### 5.1 T220208 - Use and Development of a Place of Worship at 14 O'Sullivan Street Pakenham - July 2023

**File Reference:** {file-reference}  
**Responsible GM:** Lili Rosic  
**Author:** Frances Stipkovic

That Council refuse to grant Planning Permit T220208 for the use and development of a Place of Worship at Lot 17 PS747005 known as 14 O'Sullivan Street, Pakenham VIC 3810 on the following grounds:

Figure 3 - Ground Floor Site Plan

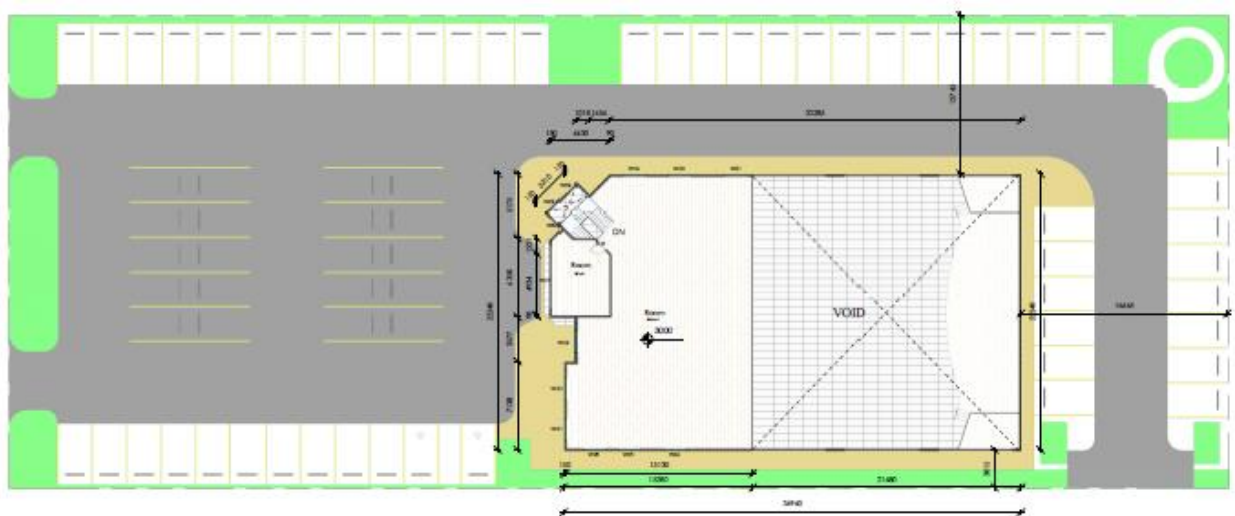
The built form is to be located near to the south-east corner of the site, with the predominant area of car parking to be located within the frontage of the site.

The existing crossover is to be modified to result in two access points, with a proposed 74 car parks to be provided (46 to the front of the building, 28 to the side and rear) inclusive of two access points. Landscaping pockets are provided along property boundaries.

However, the design is unique and specific in its design to accommodate the use sought (Place of Worship) and will be at odds with 'standard' industrial design which incorporates large floor areas, promotes large vehicle movement and generally incorporates high site coverage.

The design of the built form appears specific to a niche use, and it does not have a lifespan beyond the specific needs of the Place of Worship (or other similar community uses). The high proportion of parking required for this use results in an underutilisation of the site that cannot be resolved through building design alone and will not be appropriate for a large swathe of industrial or warehousing uses in the future.

However, as detailed above, concerns are raised with the overprovision of car parking at the lack of landscaping opportunity throughout the site which could otherwise provide amenity benefit to the site.

Figure 4 - Upper Floor Plan

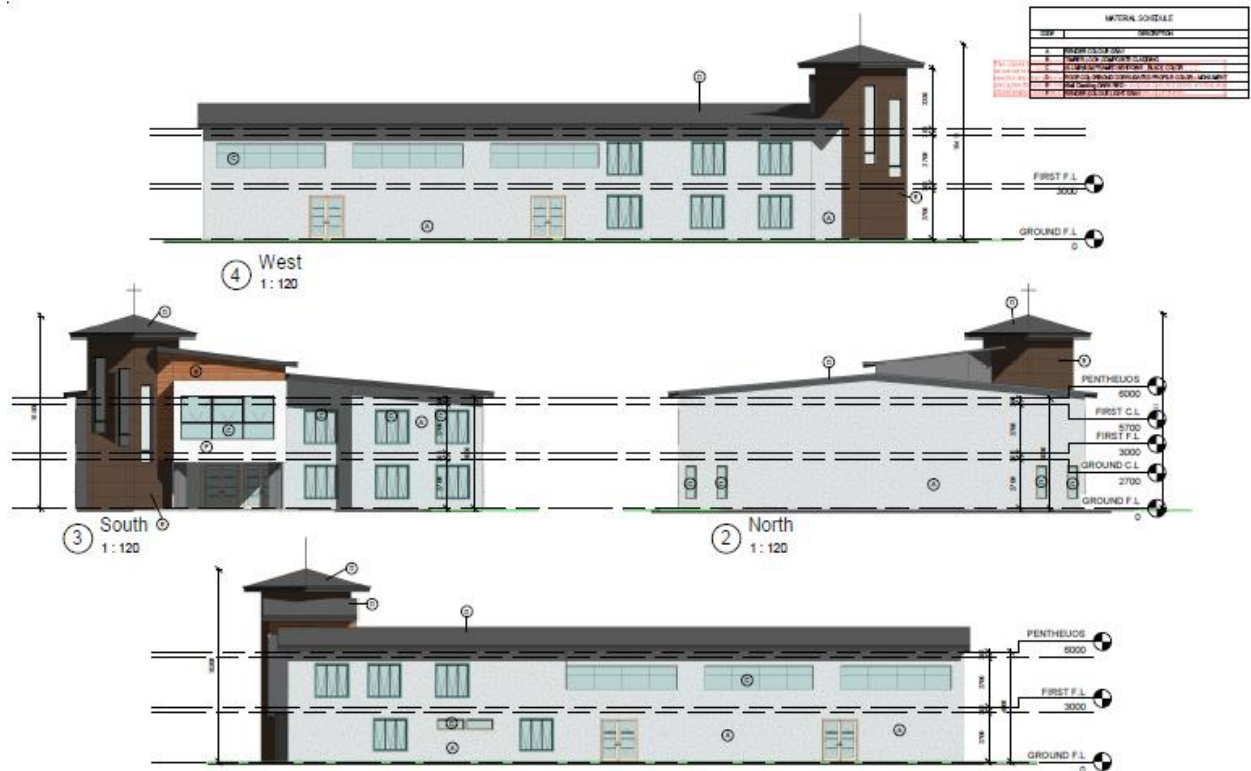
The 345m<sup>2</sup> upper floor, accessed via an internal stairwell, incorporates two separated rooms and a large void above the stage/stadium area below.
